**RECORD OF DECISION
OPERABLE UNIT #4
FLOODPLAINS/WETLANDS AREA
FIELDS BROOK SITE, ASHTABULA OHIO**

Fields Brook Site, Operable Unit IV, Floodplains/Wetlands Area, Ashtabula, Ohio

I. Comments to 11/96 FWA Proposed Plan:**A) Written Comments**

Figure 1: Fields Brook Superfund site

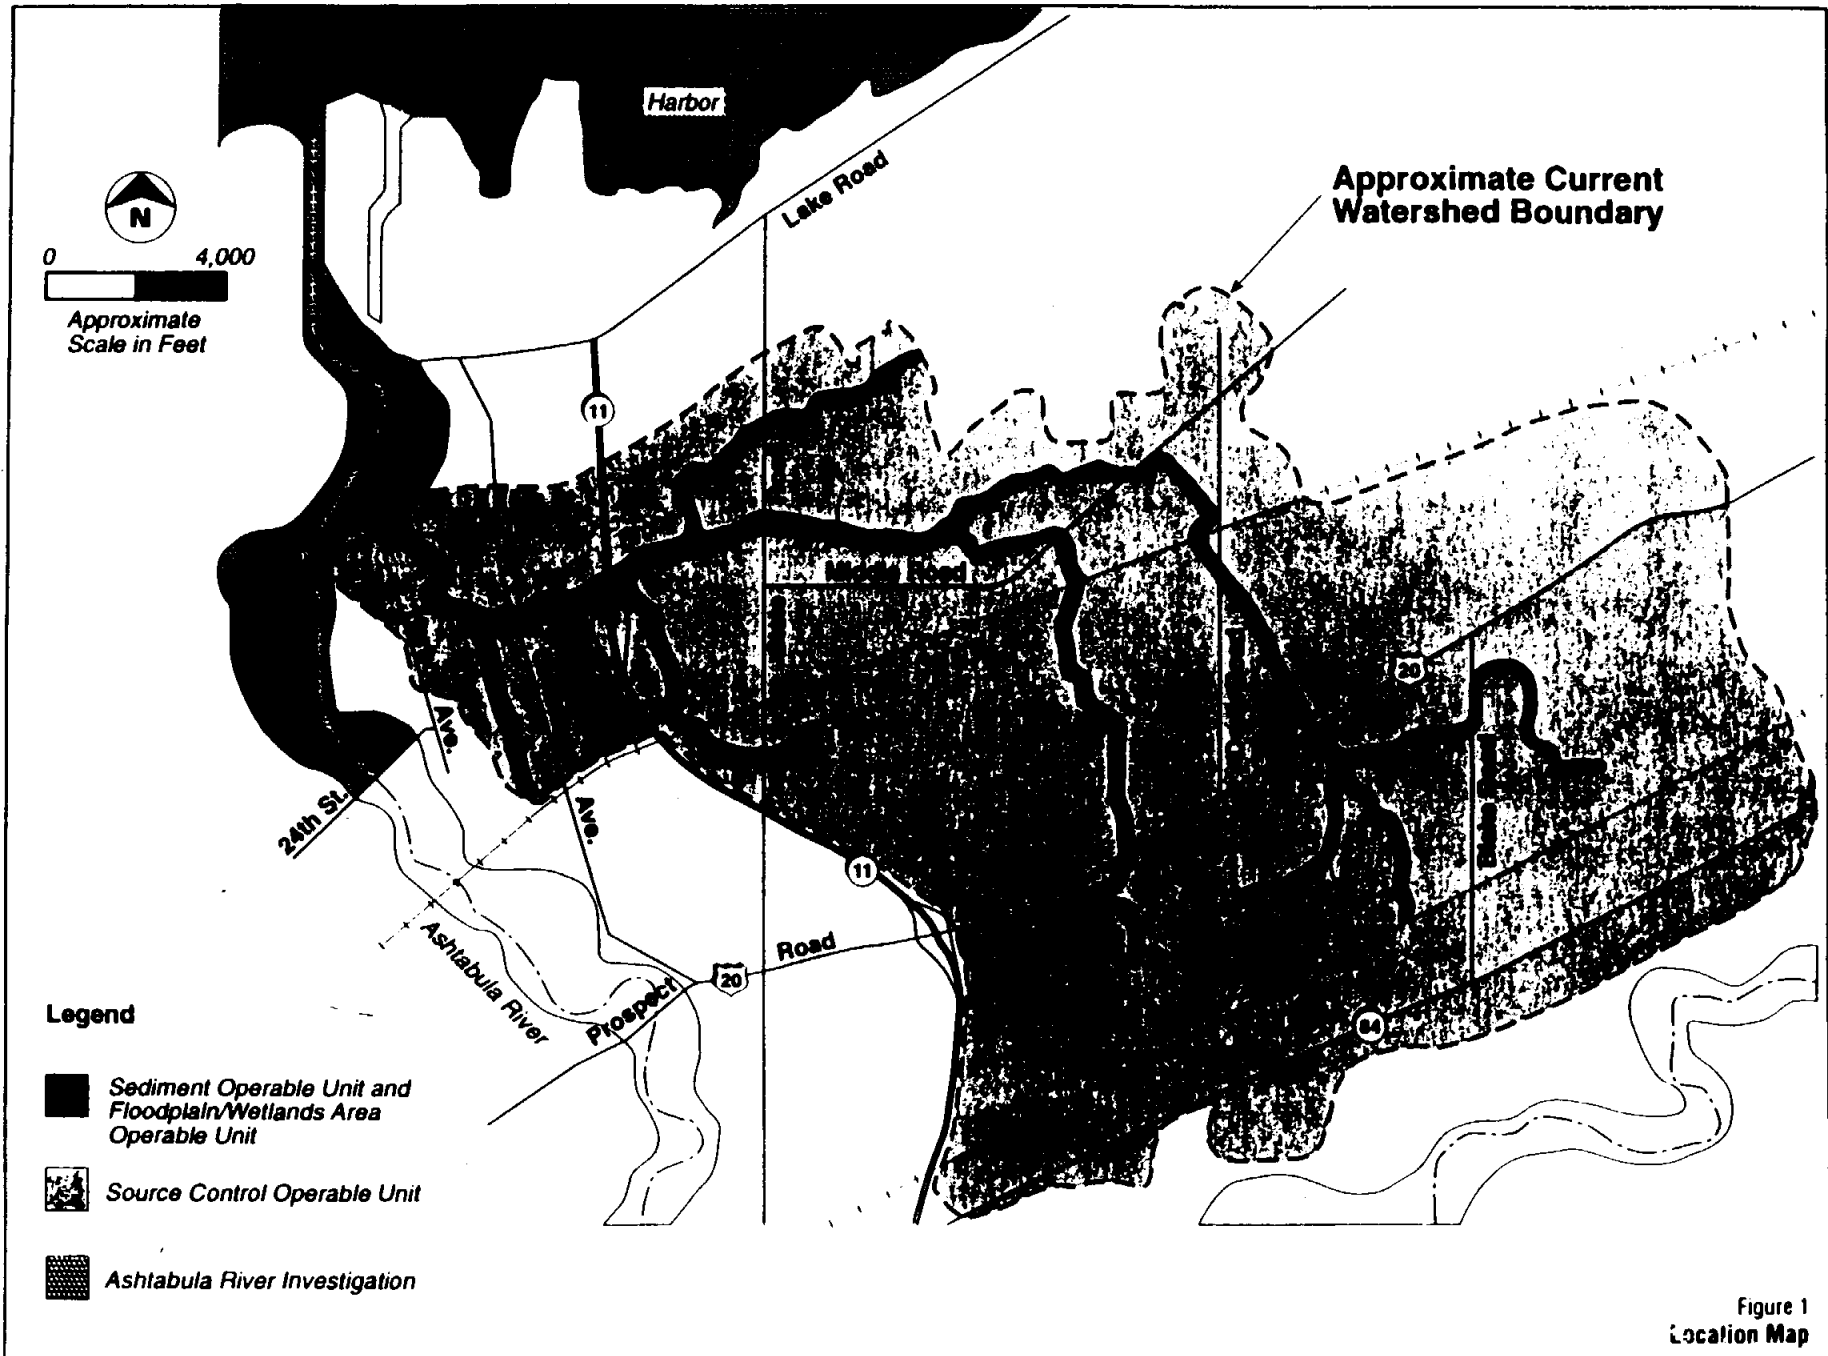
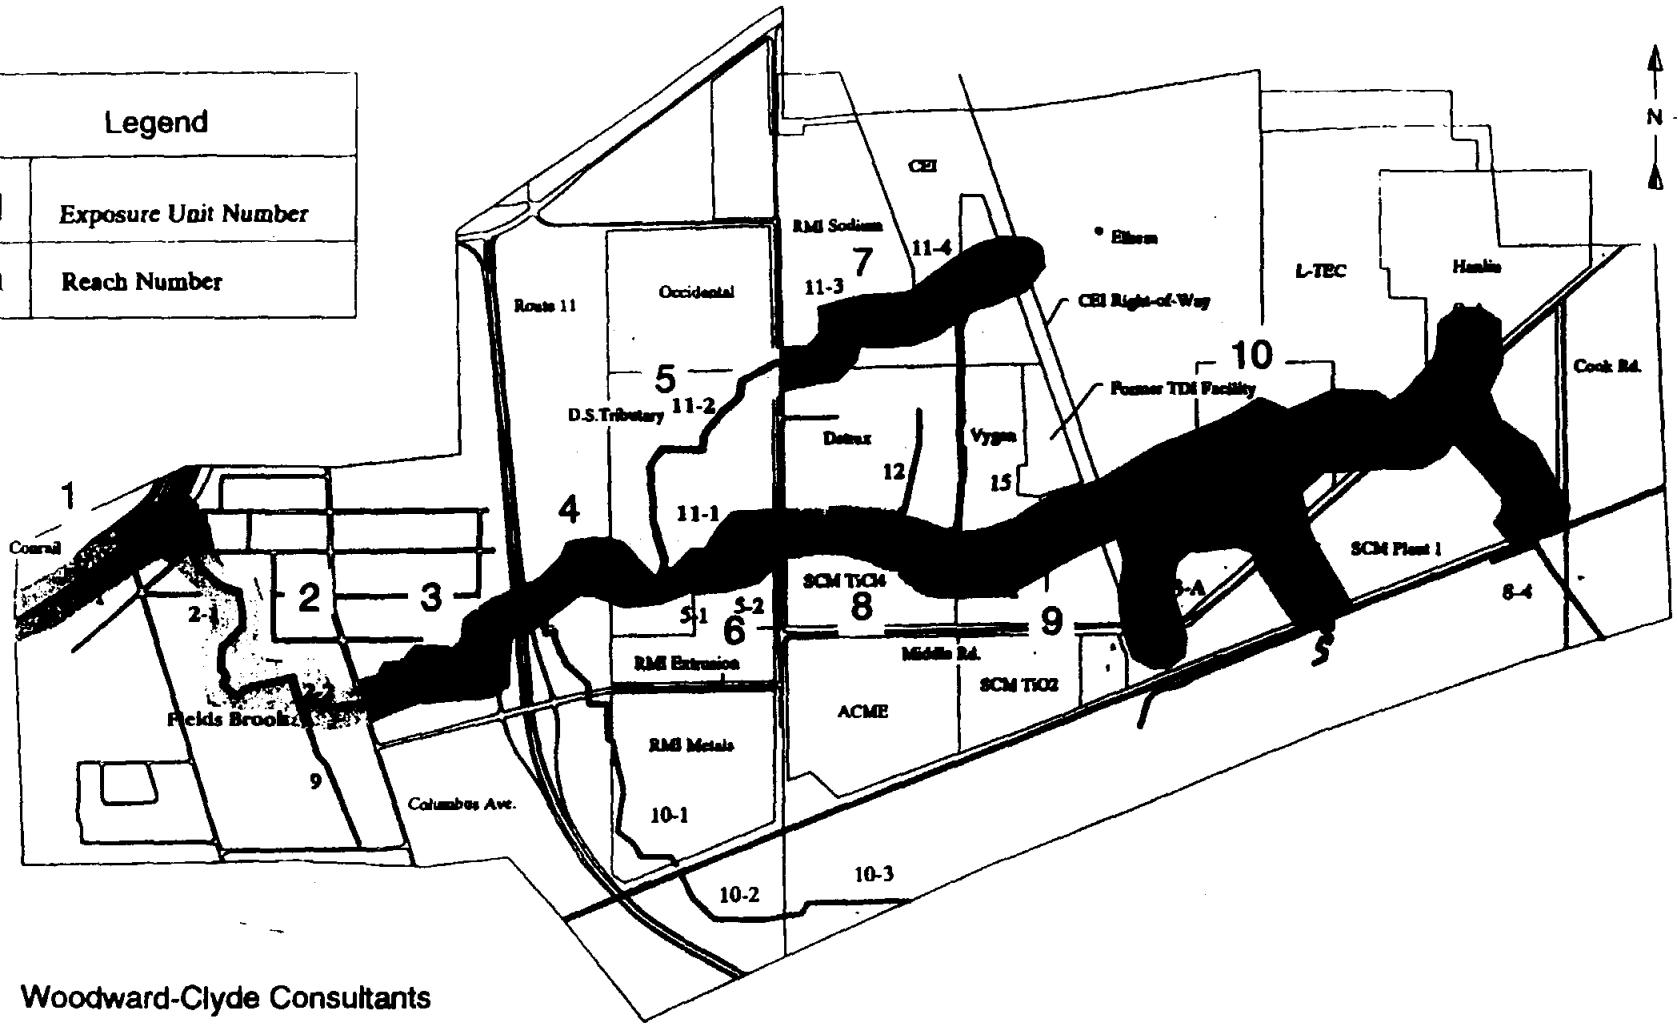
Comment: Figure 1 does not accurately depict the SOU and FWA investigation areas. The Source Control Operable Unit is not shown.

Figure 9: On-Site Landfill Cross-Section

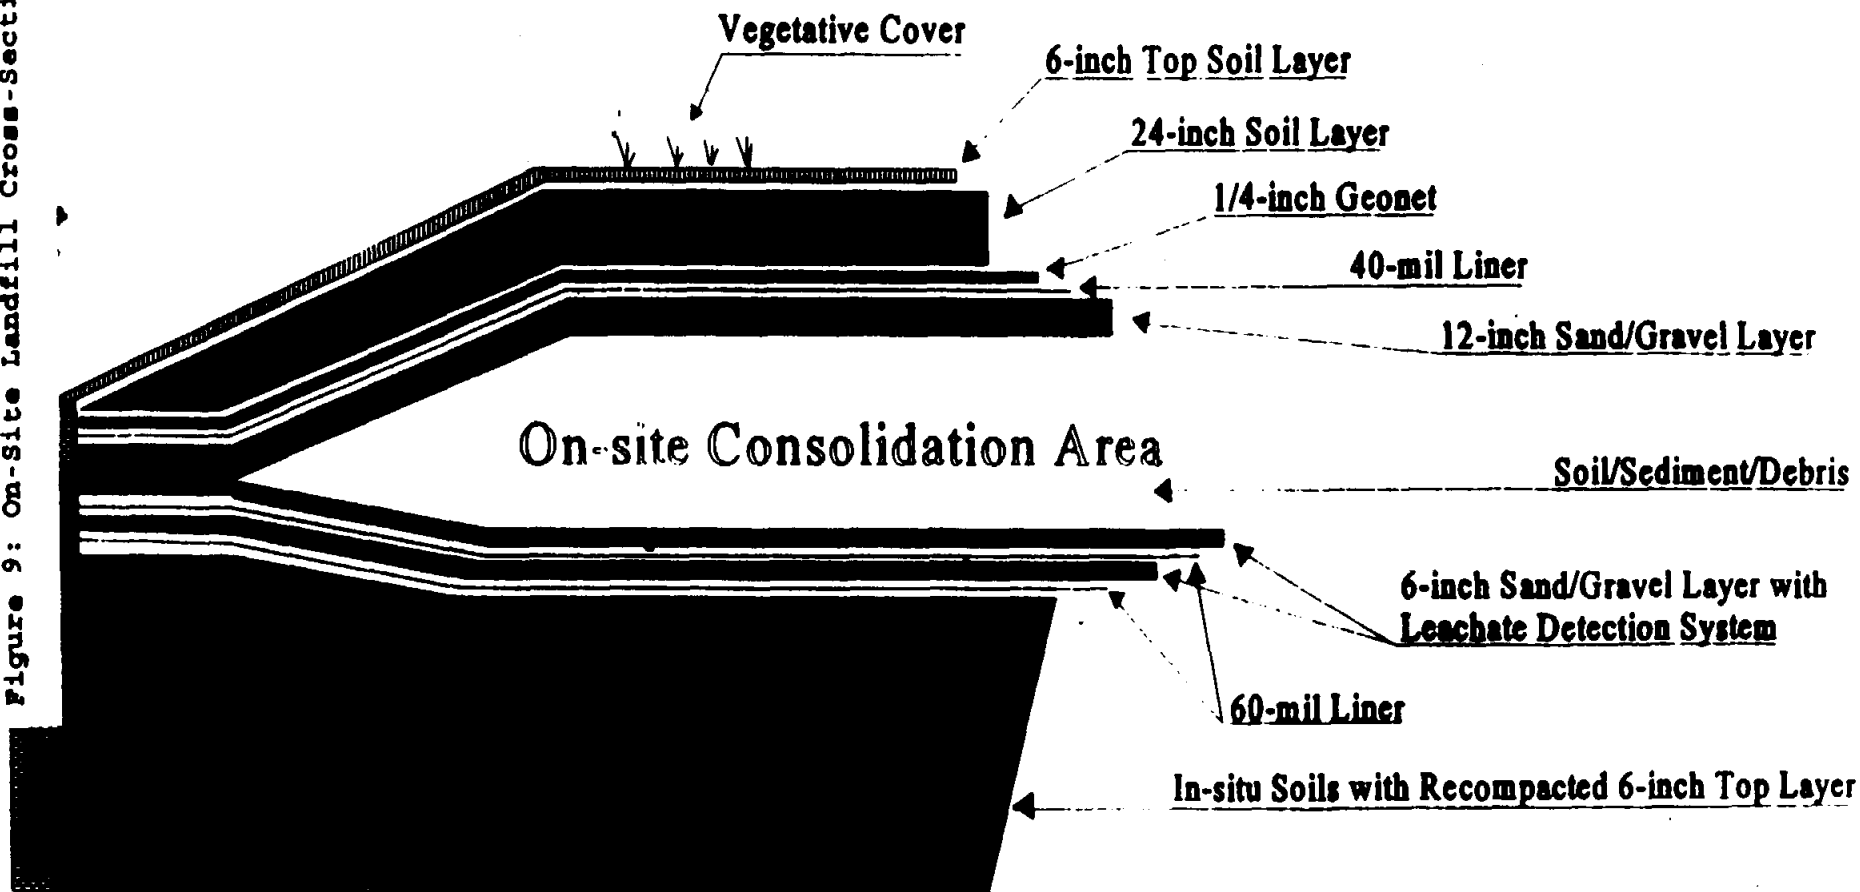
Comment: Page 7, item B), Landfill Requirements: The description of the on-site landfill should be referred to as the on-site consolidation area, to be consistent with the FS text and language used to describe this area by the PRPs.

Response: The on-site landfill may be described either as a landfill or a consolidation area, and inconsistencies regarding the reference to this unit would not change the components or requirements for the installation or operation and maintenance of this unit. Thus, either of the two terms may be acceptably used interchangeably, and no text change is required.
